Re: Updated Plans for Schoolhouse Apartments Rockland located at 6 Delprete Avenue, Rockland, MA.

RE: Schoolhouse Apartments – Chapter 40B Comprehensive Permit – Response to Amory Engineers, P.C. Peer Review

Subject: Schoolhouse Apartments Rockland

BCM 12/10/2021 1"=30' 220-160 FORM A **PLAN** DATE DWG. NO: ANR-1 © MCKENZIE ENGINEERING GROUP, INC

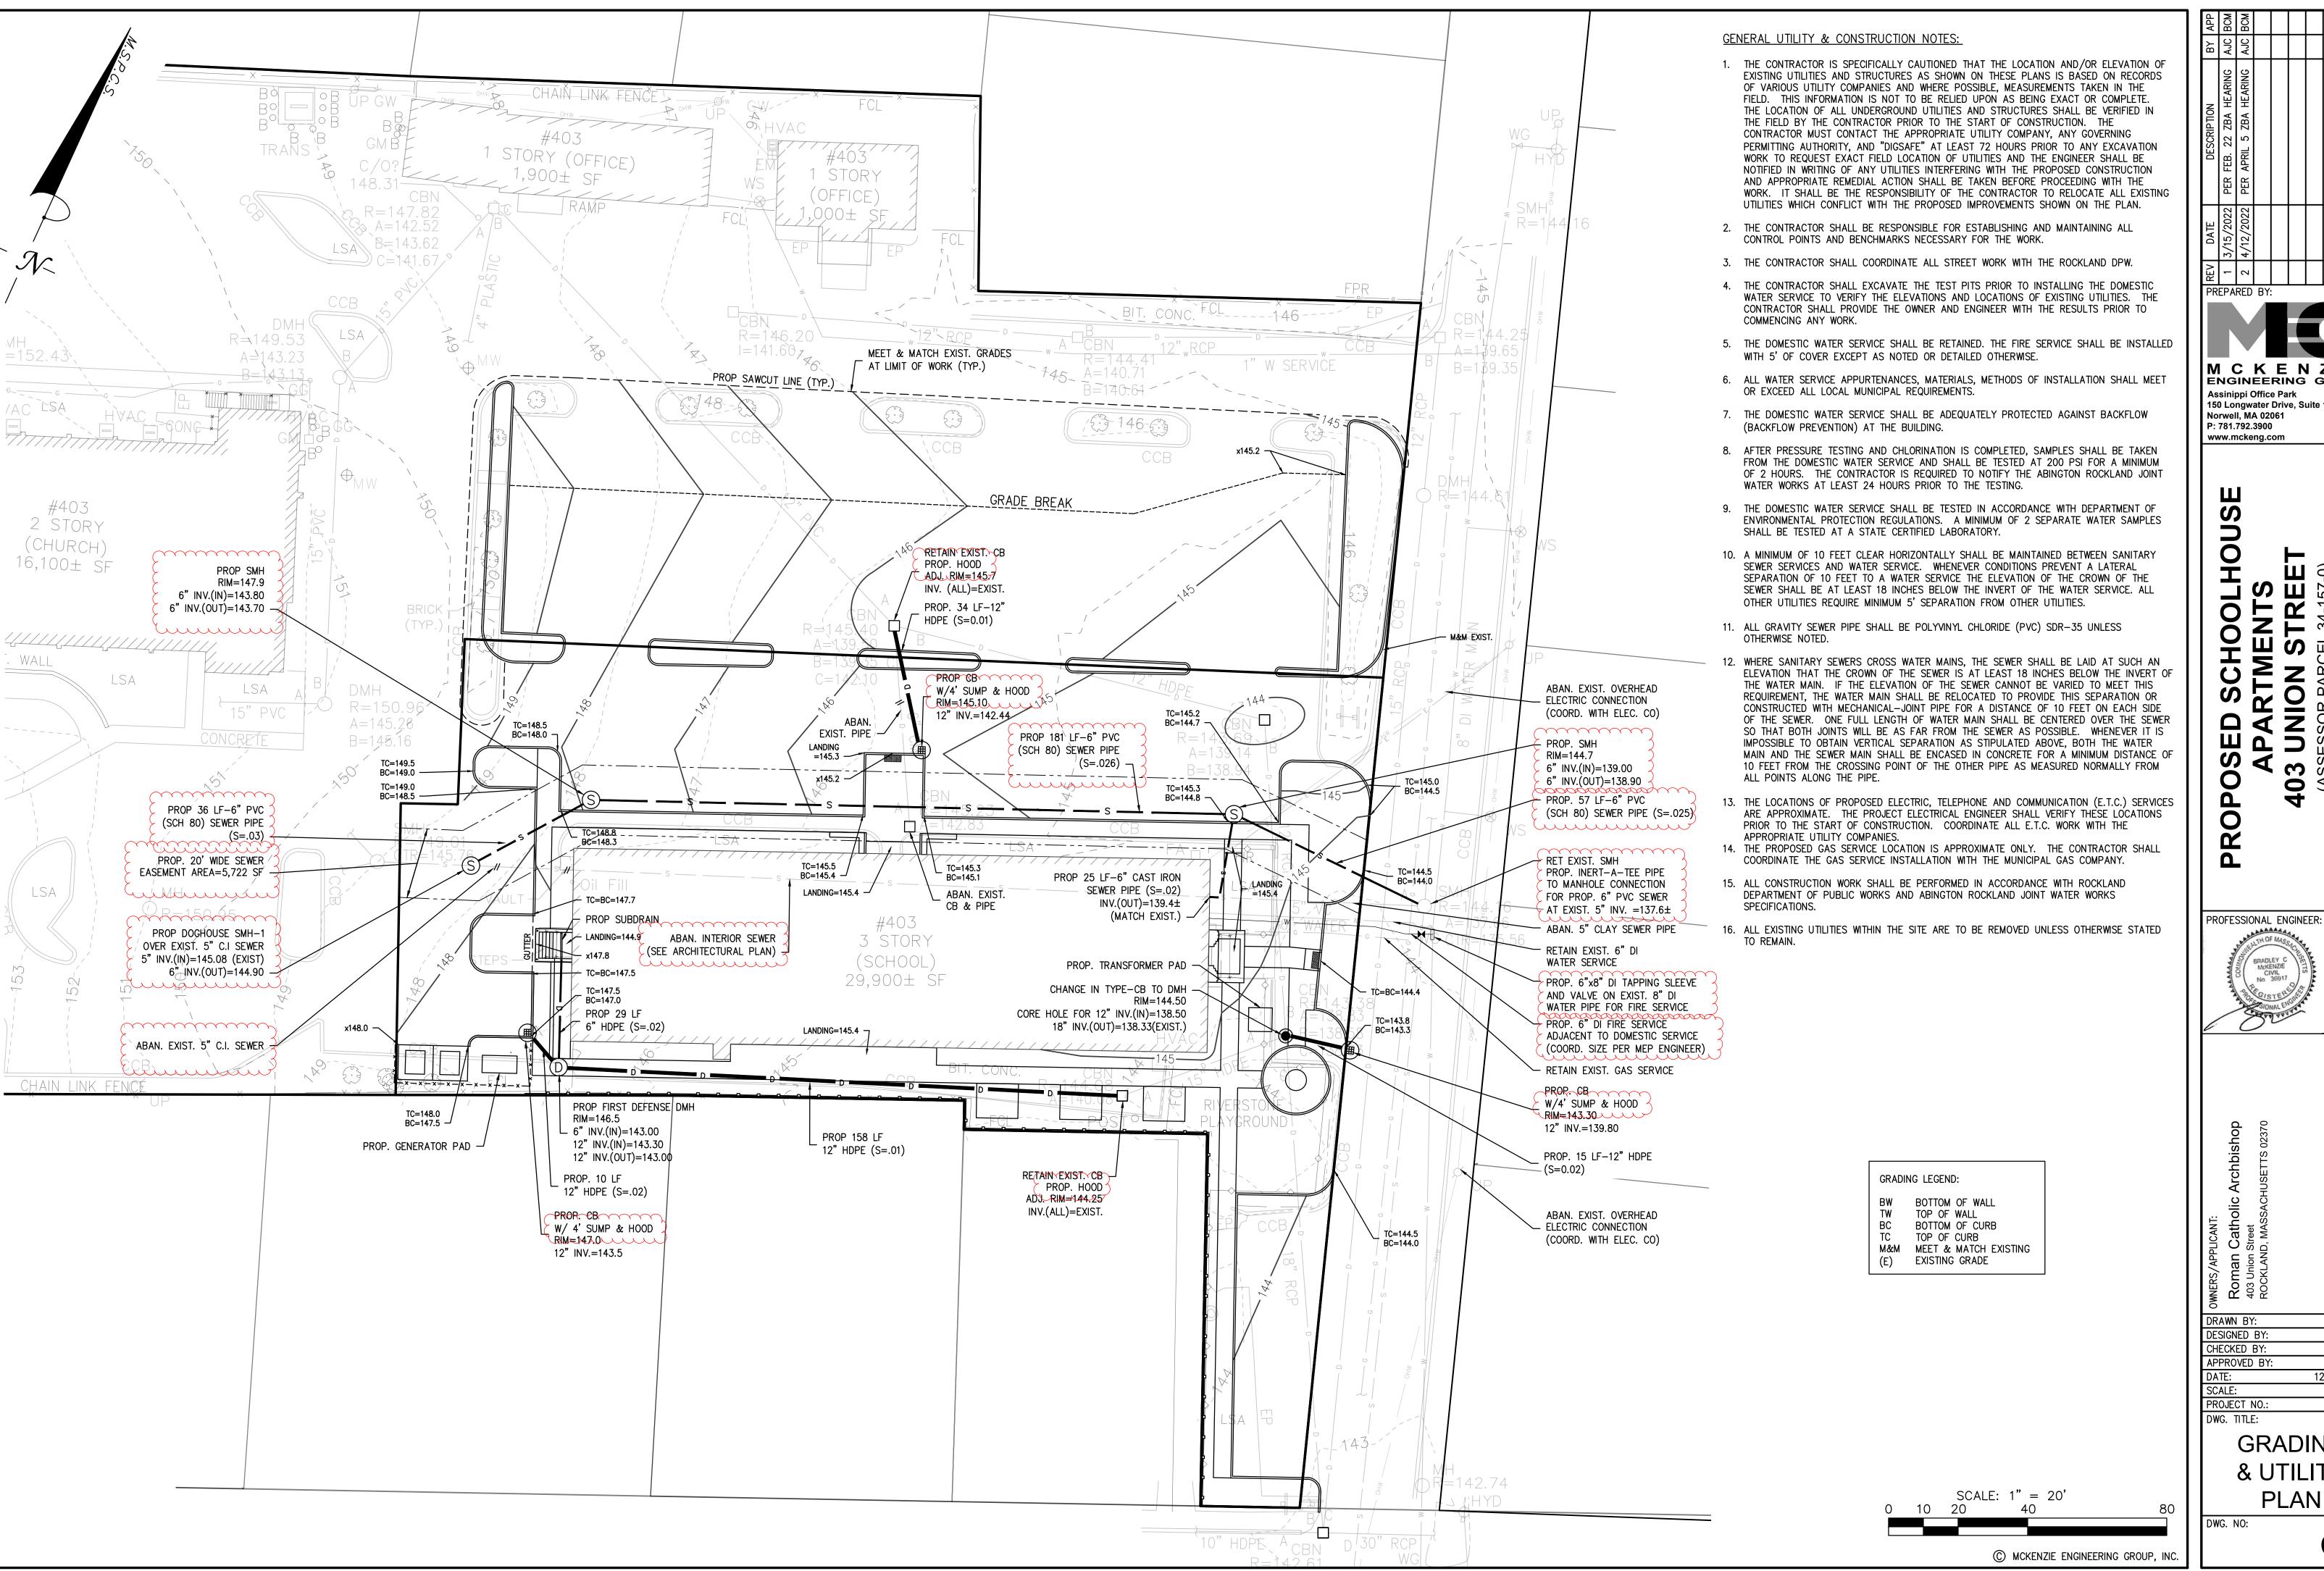
- 3. We note that when the existing lot is subdivided, easements will be required for shared stormwater infrastructure, sewer infrastructure, parking and access/egress.

- Easement will be provided for as required. A Reciprocal Easement document has been prepared as part of the lot creation which will legally allow access to both parcels and will be recorded with the lot. In addition, a 20' sewer easement is proposed across Lot A to provide access rights to the sewer infrastructure. See ANR Plan, Sheet ANR-1, and Grading and Utility Plan, Sheet C-2.
